Subject: Duke Energy Carolinas, LLC (Duke Energy)  
William States Lee III Nuclear Station – Docket Nos. 52-018 and 52-019  
AP1000 Combined License Application for the  
William States Lee III Nuclear Station Units 1 and 2 (Lee)  
Supplemental Information Related to Design Changes to the Circulating  
Water System  
Ltr# WLG2011.11-04

**FSAR Changes to Text, Tables, and Figures Related to the Circulating Water System**

This enclosure provides changes to William States Lee III FSAR resulting from the change in design from three cooling towers per unit to two cooling towers per unit as follows:

FIGURE 2.3-275

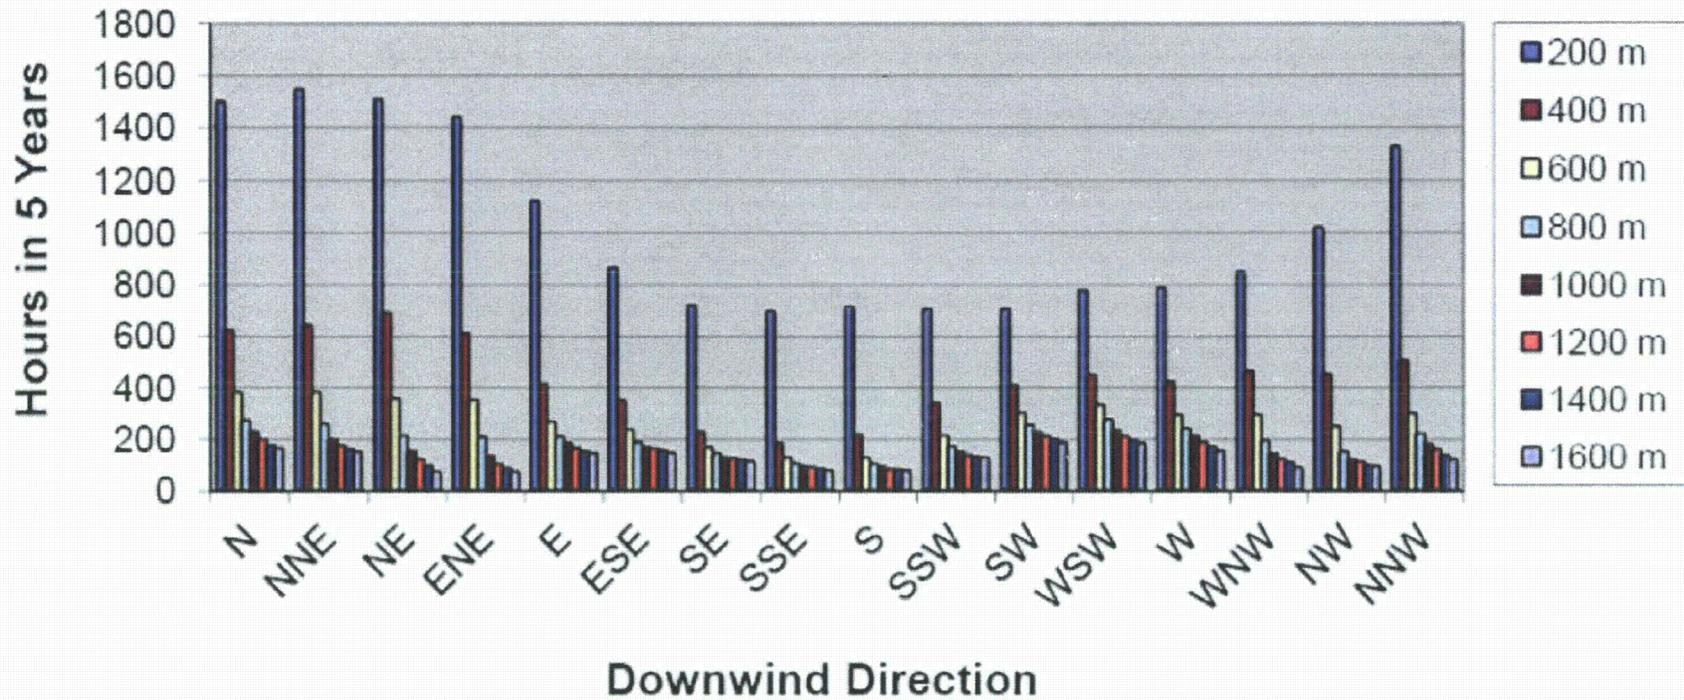
The SACTI results, as presented in [Table 2.3-278](#), indicate that the majority (i.e. >50 percent) of the visible plumes do not reach 1000 meters downwind and ~~200-300~~ meters in height. ~~It also shows that~~ The longest and largest visible plumes occur in the winter with smaller plumes occurring in the spring and fall seasons due to the cold air in winter causing condensation of the moist plumes more readily than in the warmer seasons (i.e., cold air has a much smaller capacity of holding water vapor). The summer visible plumes are noticeably smaller since warmer ambient air results in less condensation of the moist plumes due to its ability to accommodate higher water vapor concentrations. On an annual basis, 40 percent of the plumes reach ~~500~~**400** meters downwind and ~~230~~**170** meters in height. The winter visible plume length frequency as a function of direction is shown on [Figure 2.3-274](#). The winter visible plume radius frequency as a function of ~~distance-direction~~ is shown on [Figure 2.3-275](#).

Visible Plume Radius Frequency - Winter  
Cooling Tower

**FSAR Figure 2.3-279**

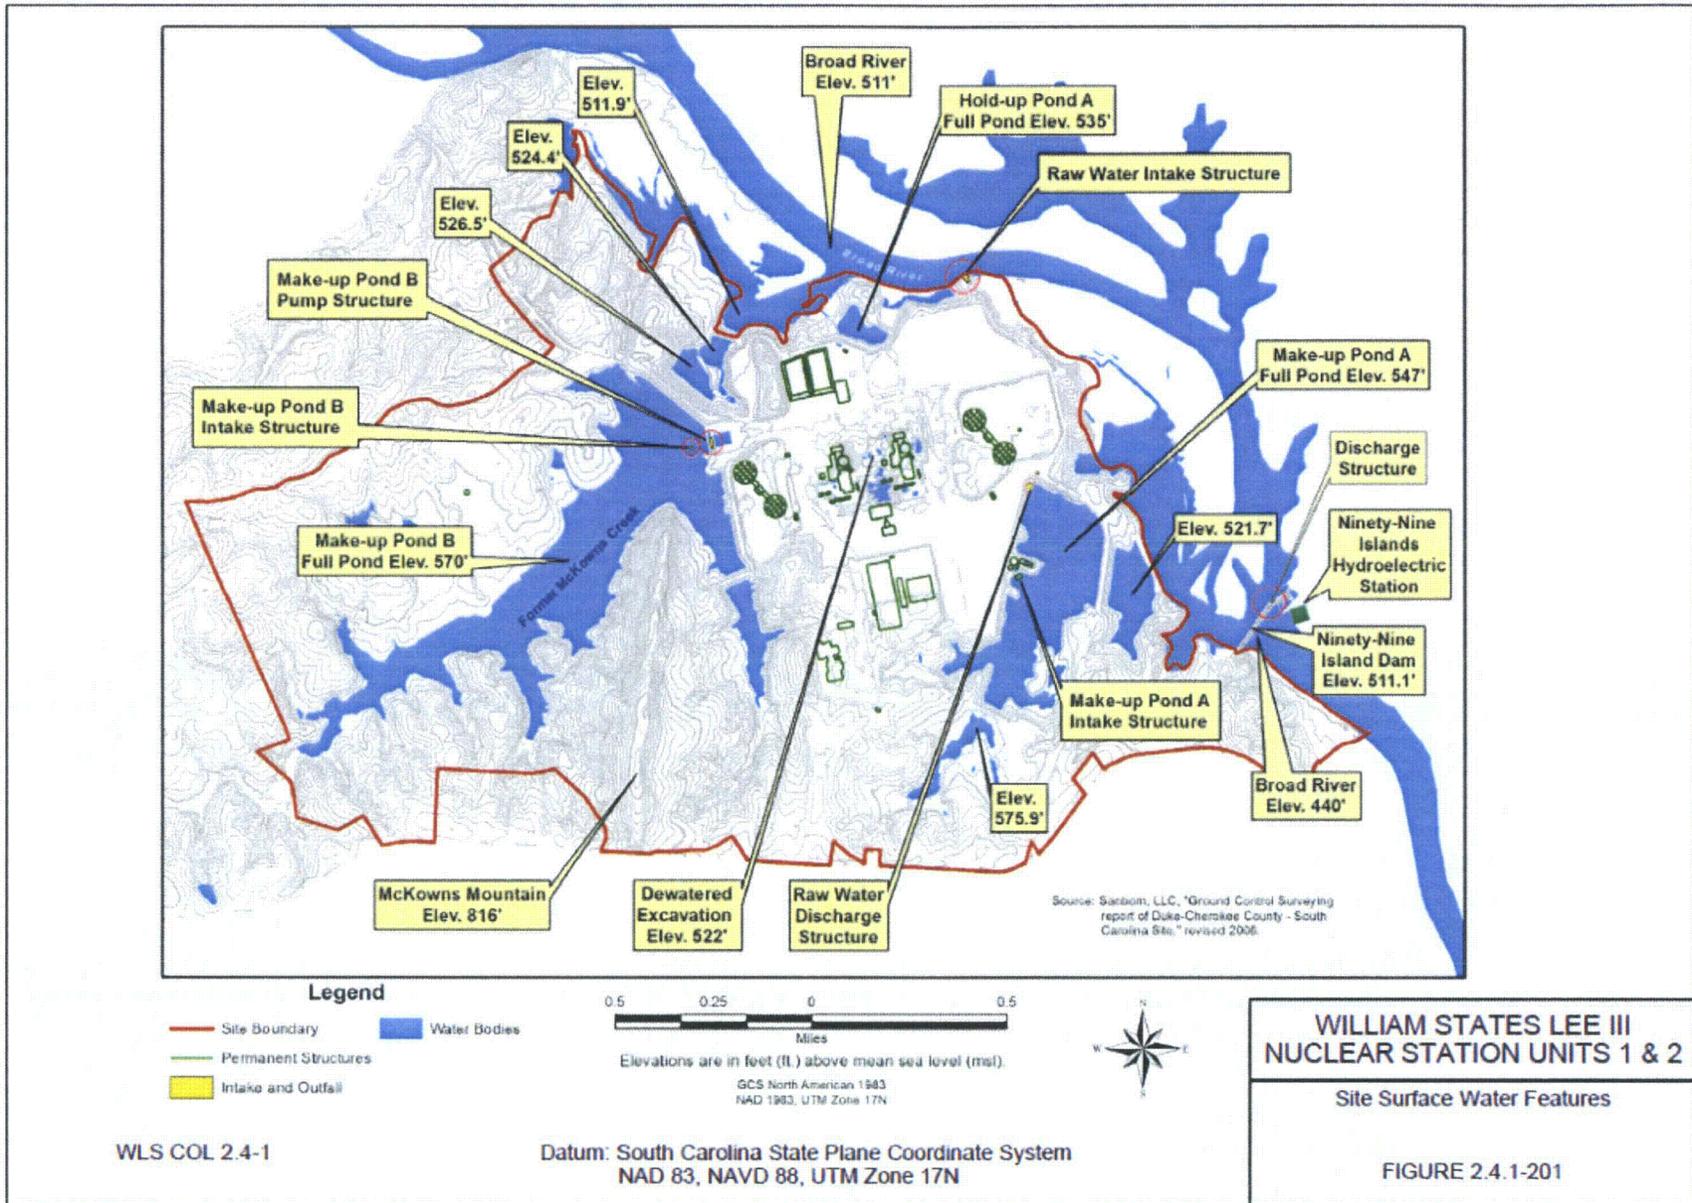
**DELETED**

**Figure 2.4.1-202**

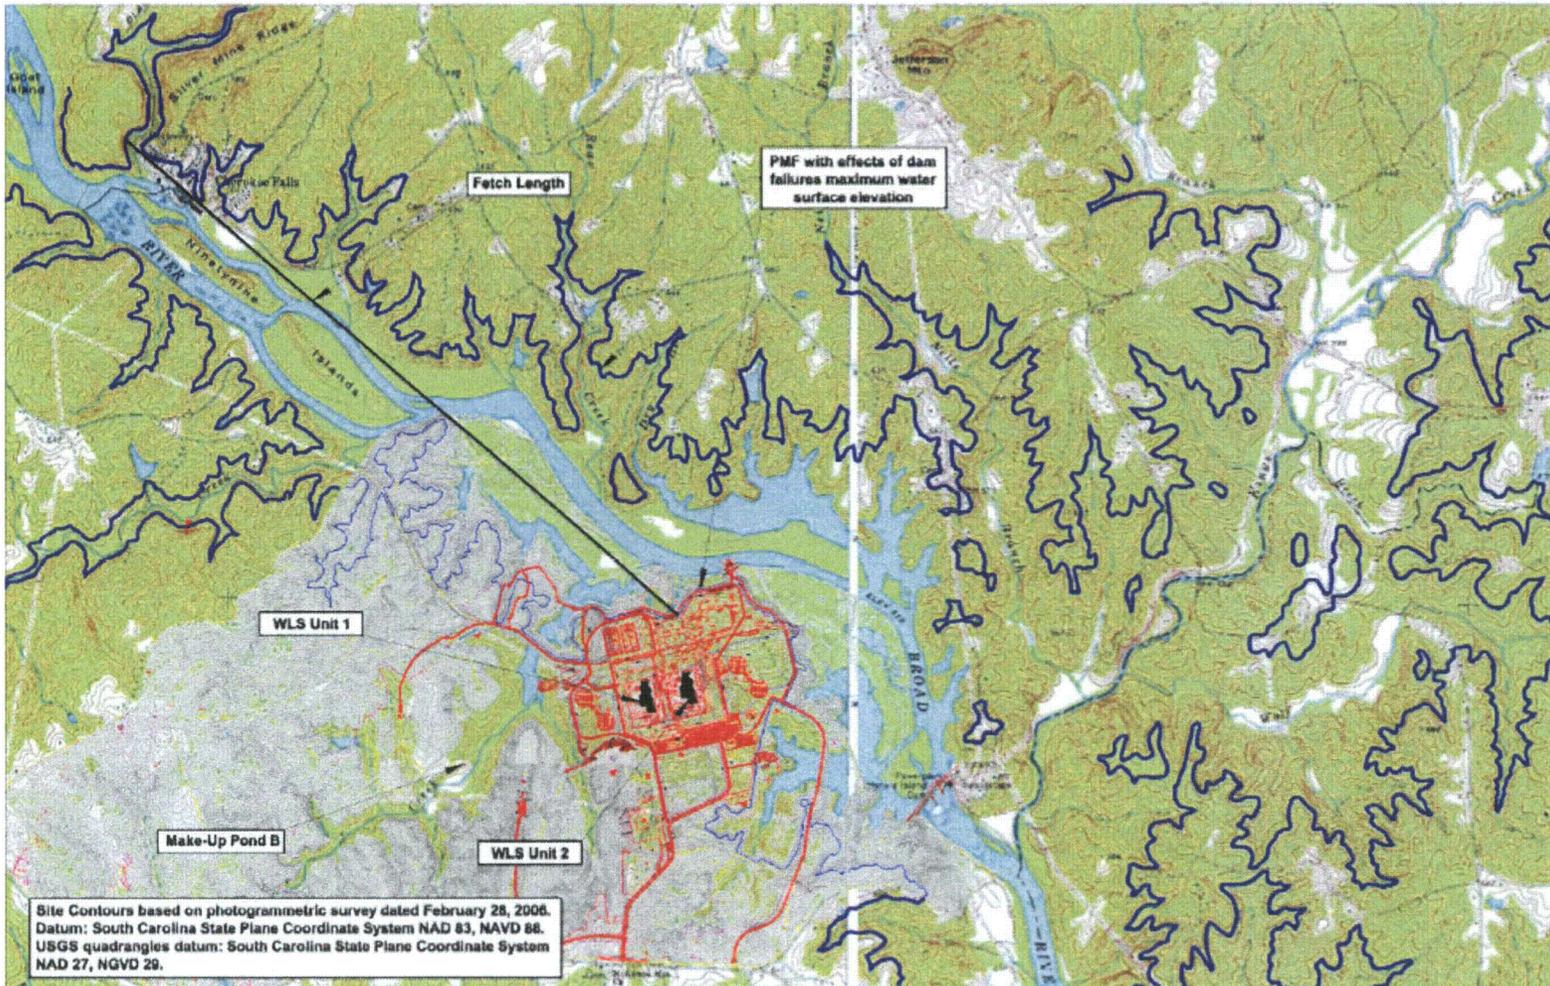
**DELETED**

(Figure deleted consistent with COLA Part 2, FSAR, Ch. 2, Subsection 2.1.1.4 text)

FIGURE 2.4.4-201

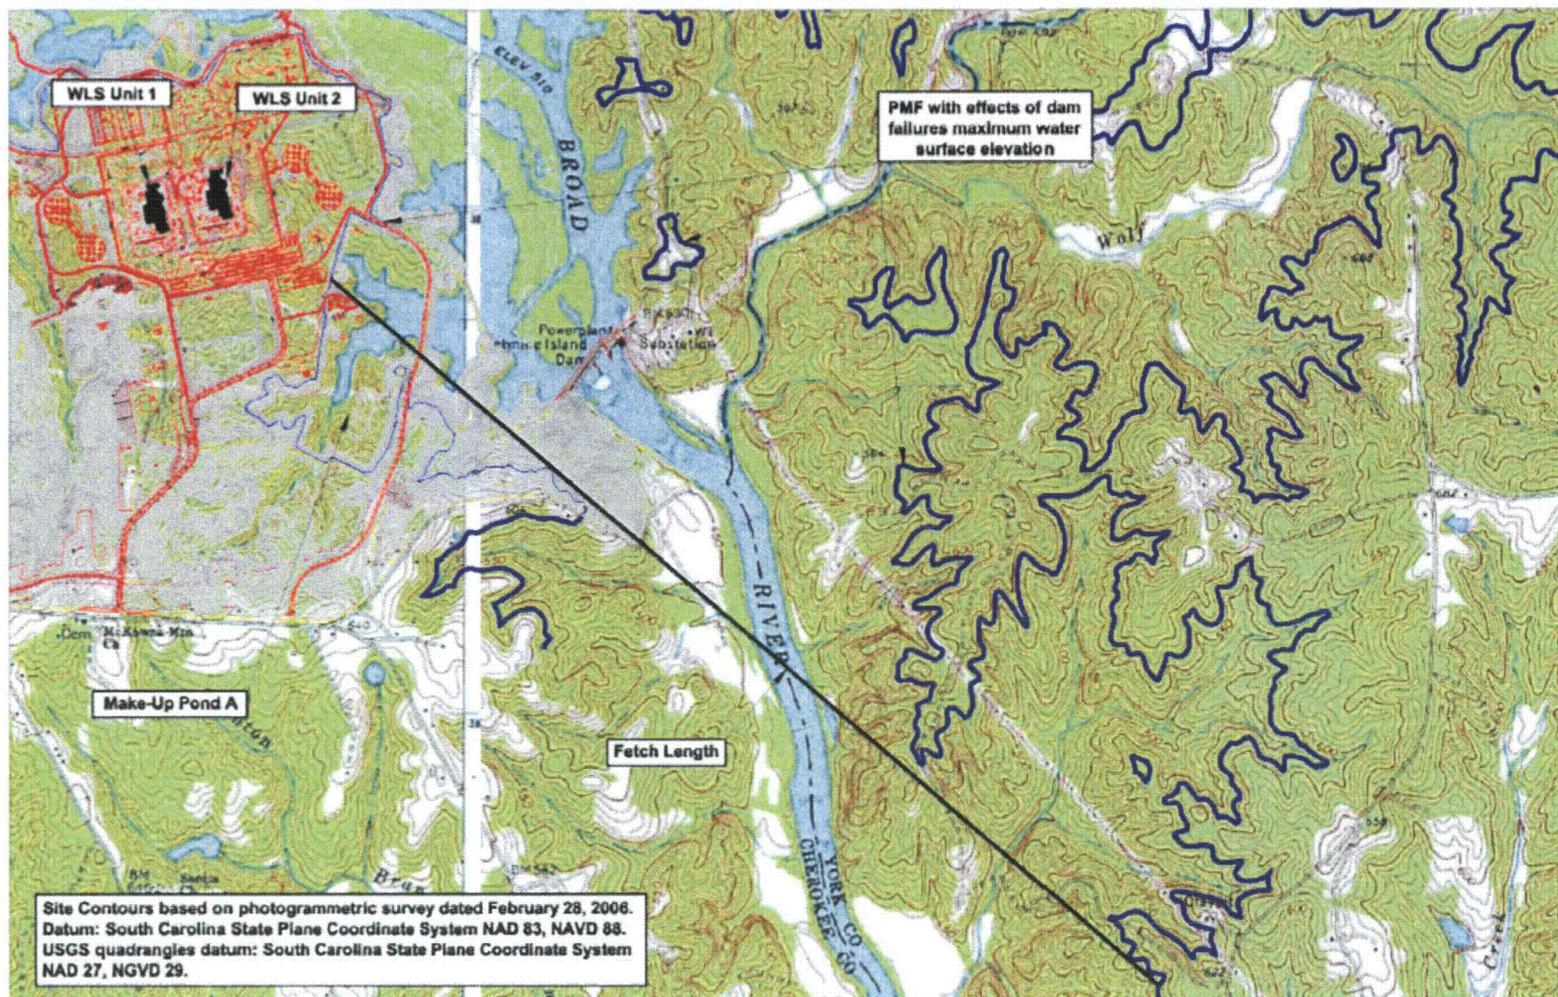
Broad River Coincident Wind Wave  
Fetch Length

FIGURE 2.4.4-202

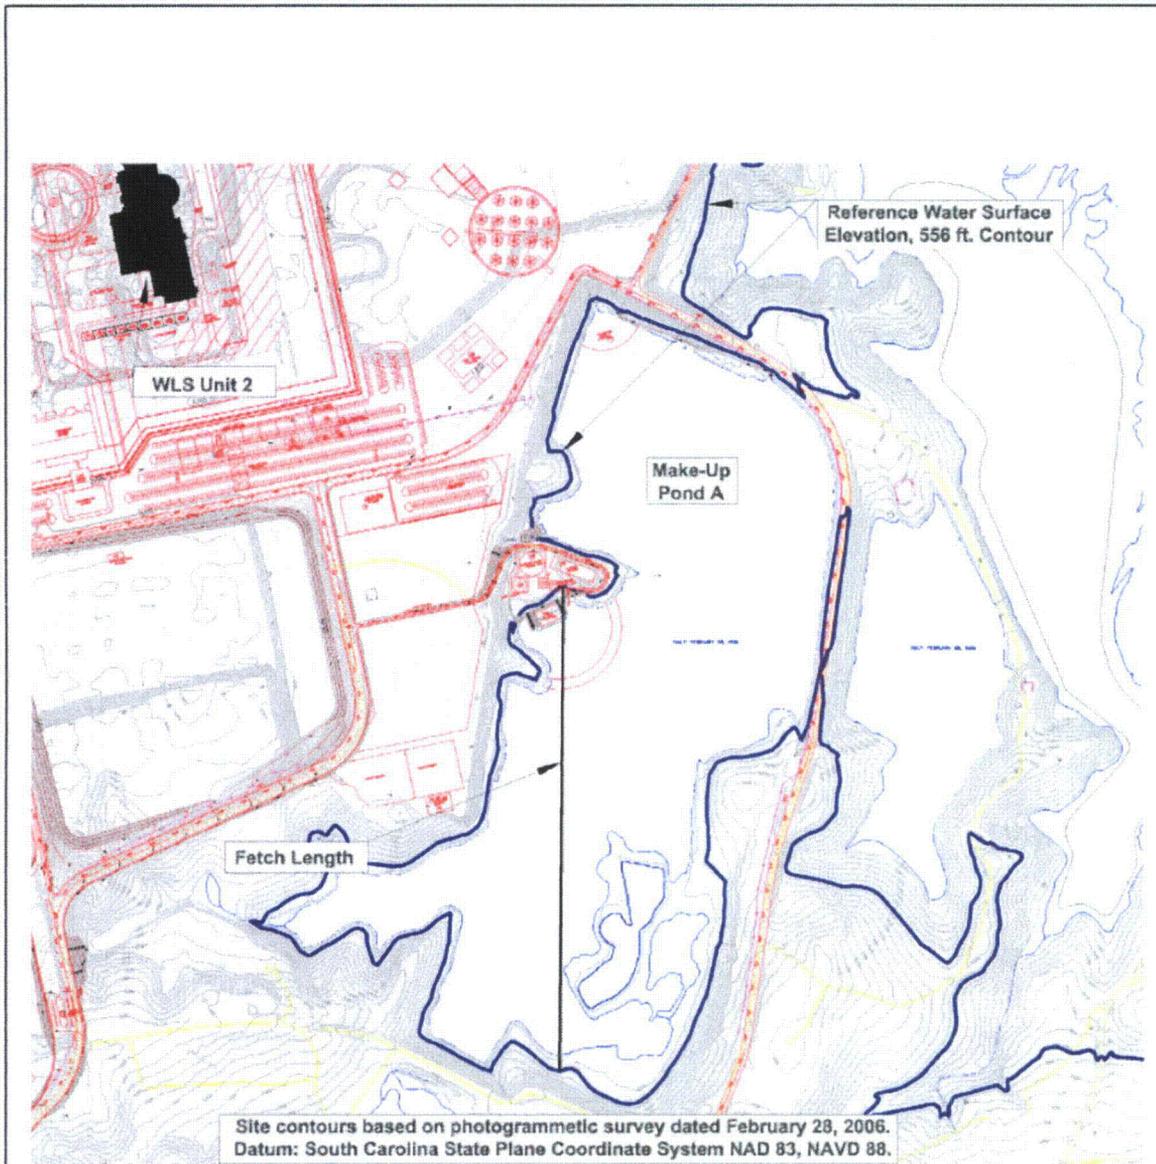
Make-Up Pond A Coincident Wind Wave  
Fetch Length

FIGURE 2.4.5-201

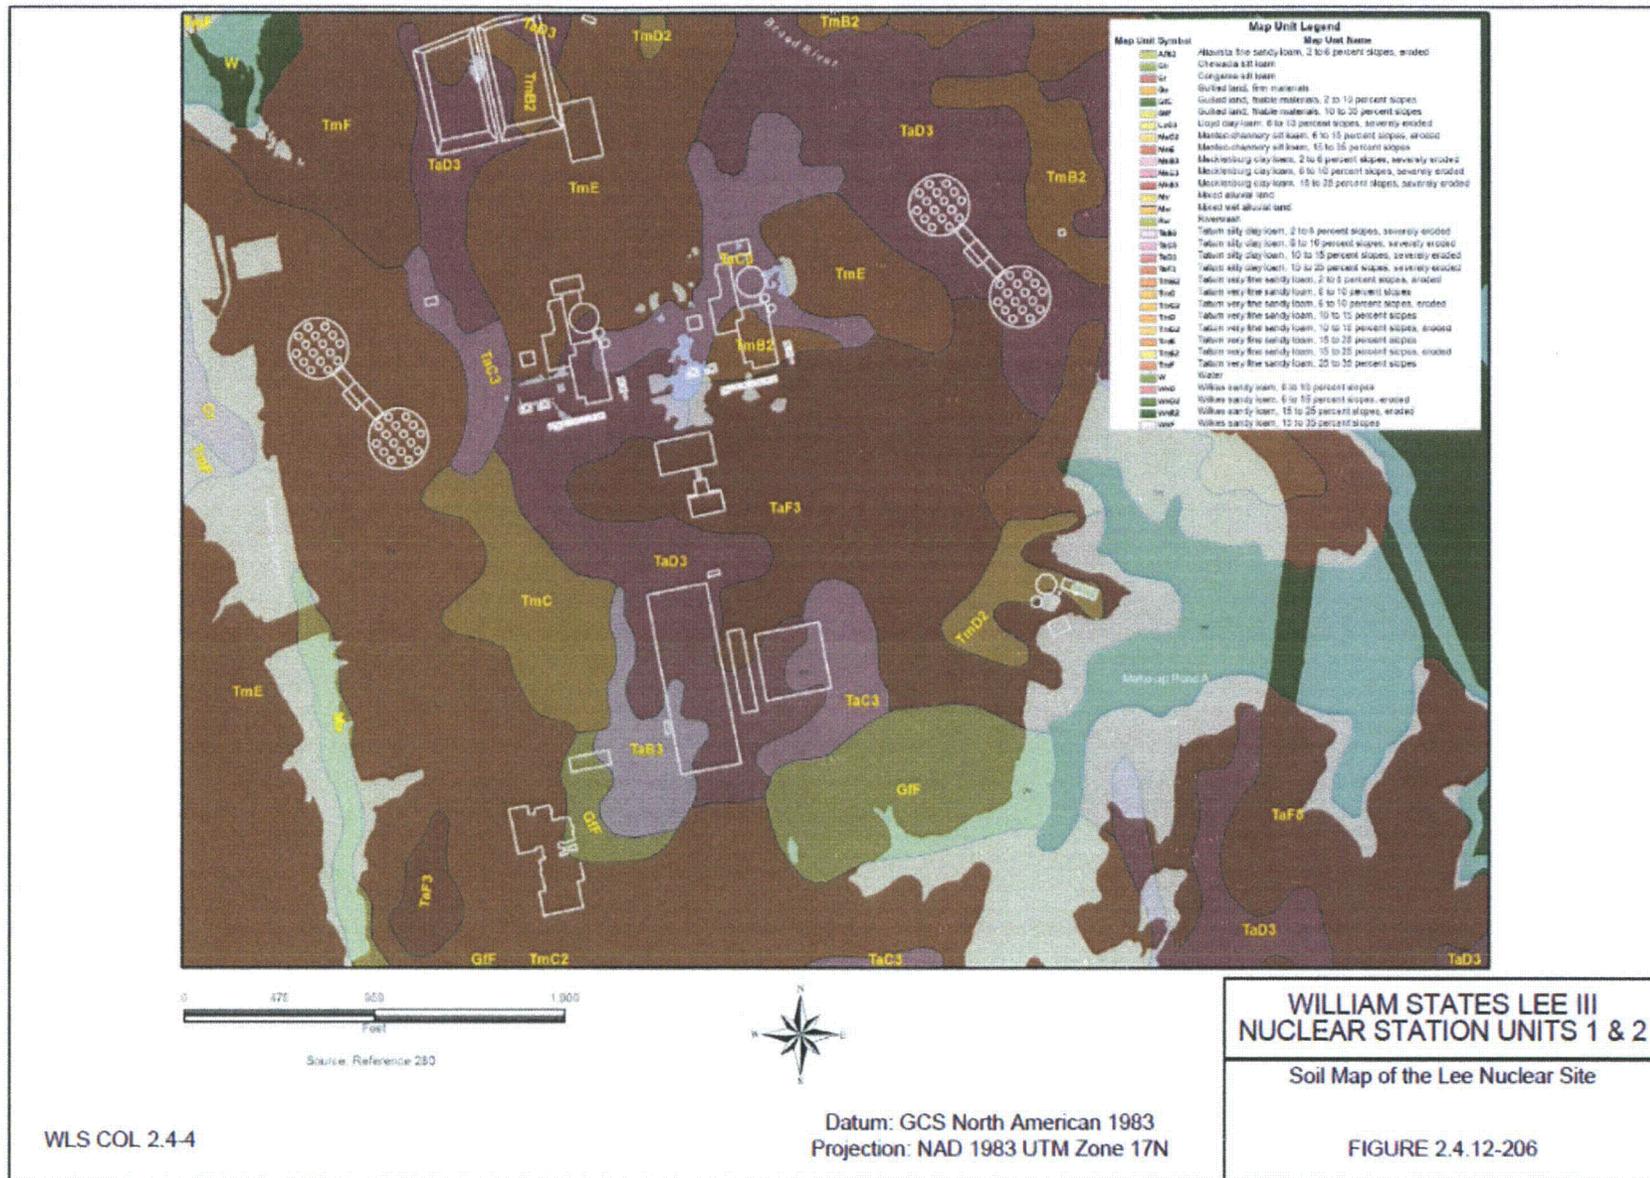
Make-Up Pond A  
Extreme Wind Speed Fetch Length
